**Perry Nuclear Power Plant
Docket Nos. 50-440; 50-441
SER Confirmatory Item - No. 34
Undervoltage Protection**

The following information is provided to amend our June 8, 1982, letter regarding SER Confirmatory Item No. 34 on undervoltage protection. (Ref. FSAR question 430.77).

TITLE	UNDervOLTAGE RELAY	
	TRIP LOGIC	
	PERRY NUCLEAR POWER PLAN	
	THE CLEVELAND ELECTRIC ILLUMINATING COMPANY	
	CLEVELAND OHIO	DWG. NO. AGM SH.1 OF 2

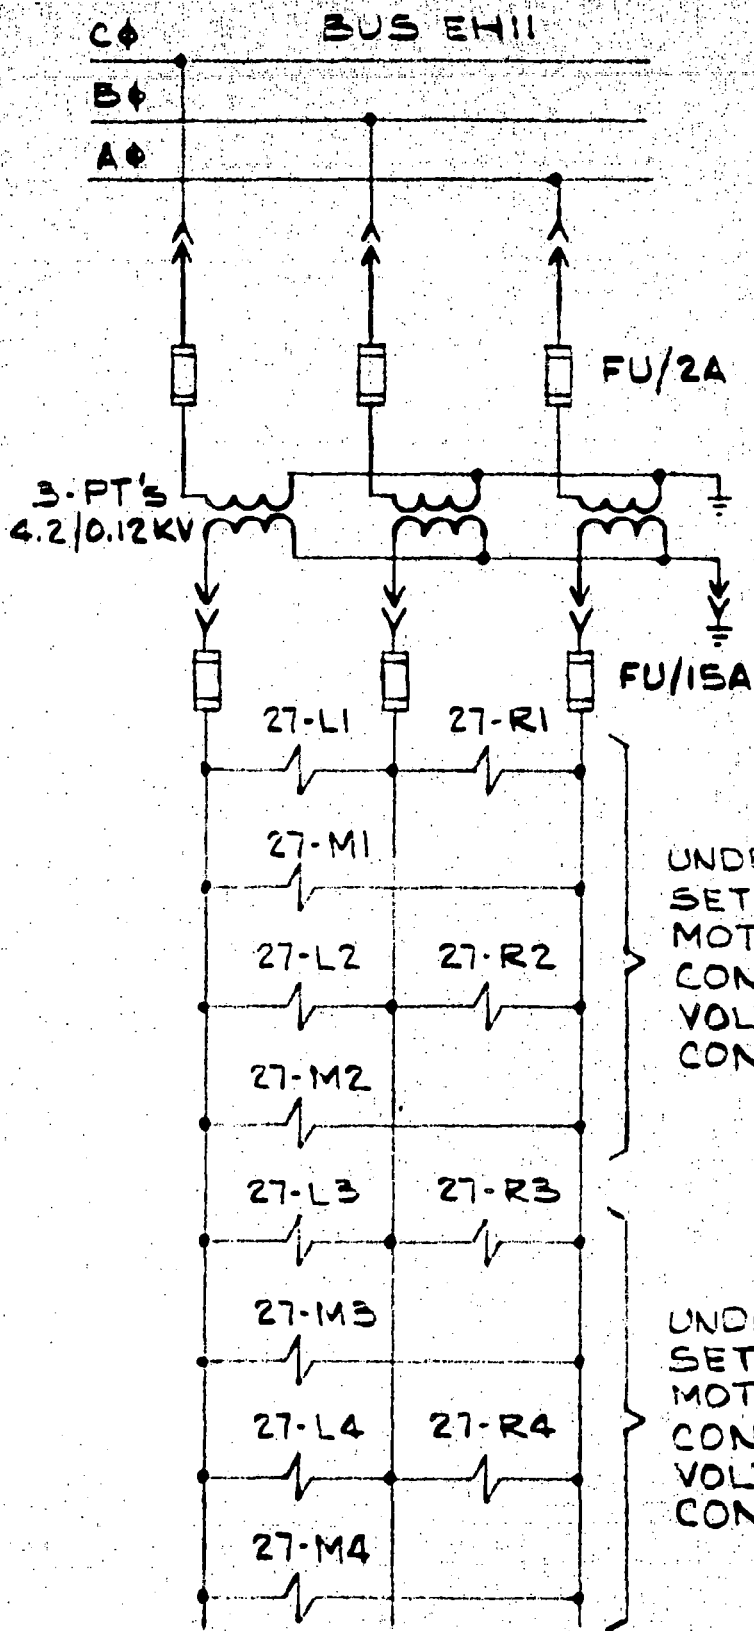
To avoid tripping the offsite breakers during normal load sequencing, the setpoint for the first level of undervoltage protection has been changed to trip at 75% of motor rated voltage instead of 86%. The three second fixed time delay will still remain in effect.

UNDervOLTAGE RELAYS
 SET TO TRIP AT 75% OF
 MOTOR RATED VOLTAGE.
 CONTACTS CLOSE WHEN BUS
 VOLTAGE IS BELOW NORMAL.
 CONTACTS SHOWN ON SHEET 2.

UNDervOLTAGE RELAYS
 SET TO TRIP AT 96% OF
 MOTOR RATED VOLTAGE.
 CONTACTS CLOSE WHEN BUS
 VOLTAGE IS BELOW NORMAL.
 CONTACTS SHOWN ON SHEET 2.

TITLE	
UNDERVOLTAGE RELAY	
TRIP LOGIC	
PERRY NUCLEAR POWER PLANT	
THE CLEVELAND ELECTRIC ILLUMINATING COMPANY	
CLEVELAND	DWG. NO.
OHIO	AGM SH. 2 OF 2

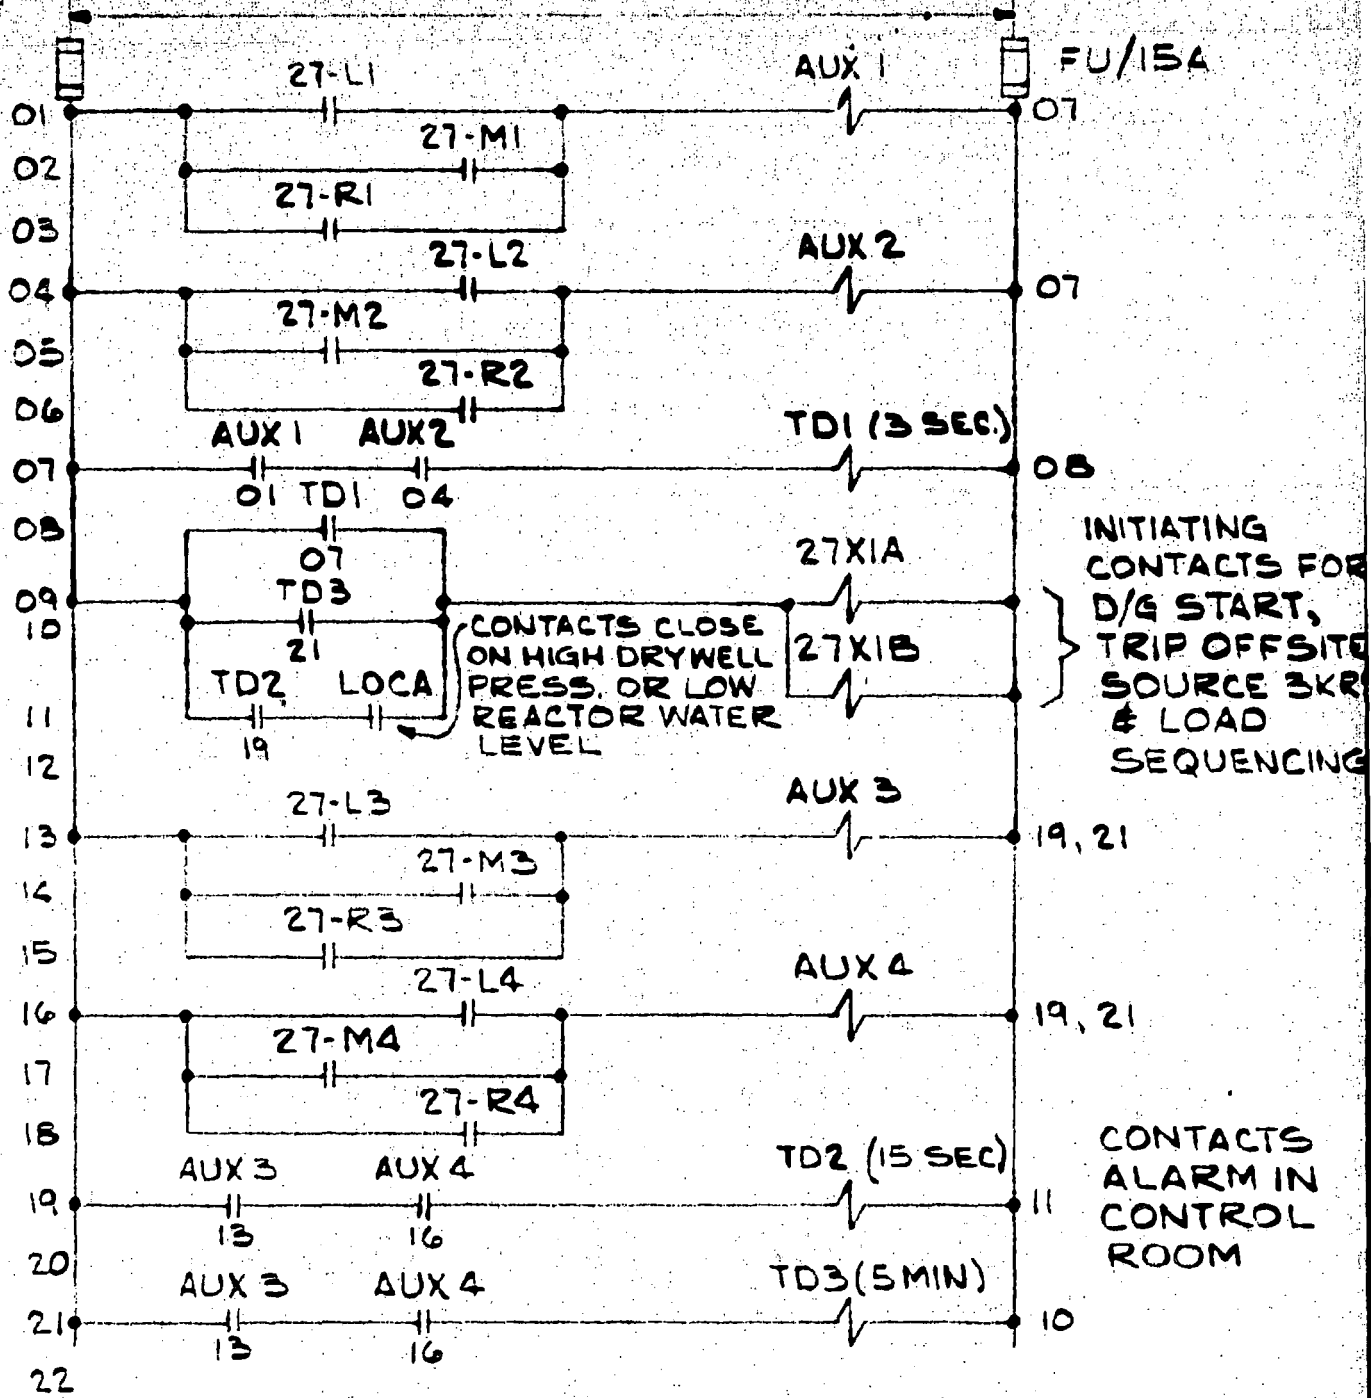
Additionally, the diesel generator start signal after the 15 second time delay from the second level of undervoltage has been eliminated. In order to prevent unnecessary engine starts, this timer will alarm only, allowing operator initiation if the diesels are needed.

The undervoltage protection will not be bypassed during load sequencing operations. The setpoint values have been selected to prevent tripping of safety busses during sequencing operations.
